Subject: URGENT - FIELD SAFETY NOTICE – INTEGRA – CUSA® Excel 23KHz Straight Handpiece – Reference: C2600 – FIELD SAFETY ACTION

Legal manufacturer: Integra Lifesciences, IDA Business and Technology Park, Sragh Ave, Tullamore, Co. Offaly – IRELAND. IE-MF-000003849

Figure 1: Example of Cracked Housing

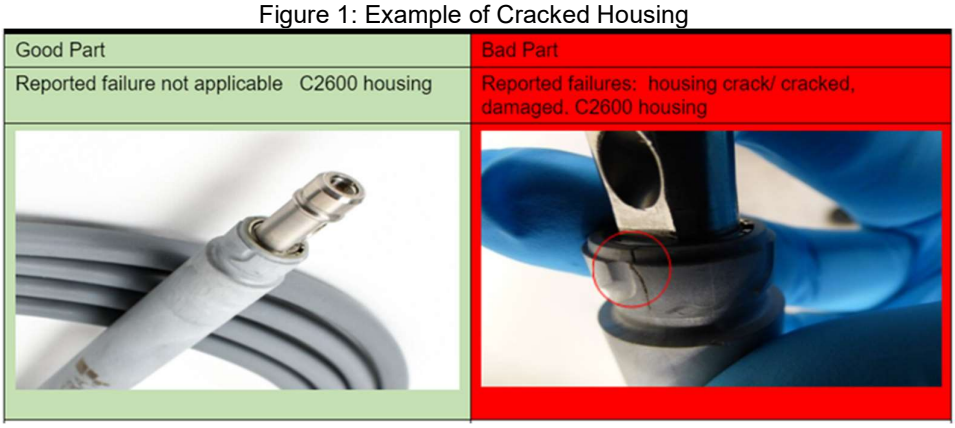
The decision to conduct a voluntary correction of the product was based on the following: through an internal investigation of customer complaints, it was identified that there is a potential for the CUSA Excel 23KHz Handpiece housing to crack. In order to mitigate this issue, the devices will be reworked through our service and repair process for the units manufactured prior to November 2023.

***Note:** A replacement housing was introduced in November 2023 to fix the crack housing, as such any new parts manufactured after November 2023 do not have the potential of cracked housing issue. These devices started getting distributed on December 12th, 2023.*

1. Inspect the housing for the presence of a crack – see image below.

2. The Handpiece cracked housing may be visually detected by clinical staff during inspections prior to or post-surgery. If a crack is noted, please remove the handpiece and return to Integra Service. TCS Benelux TCS.Benelux@integralife.com; TCS DACH TCS.DACH@integralife.com; TCS France TCS.France@integralife.com; TCS Italy TCS.Italy@integralife.com; *(will be added to the corresponding FSN depending on the country*). Check the box "I do have affected units" in the enclosed the reply form.
3. If a crack is not noted,

Regardless of the service contract status, the housing will be replaced free of charge during your next service.
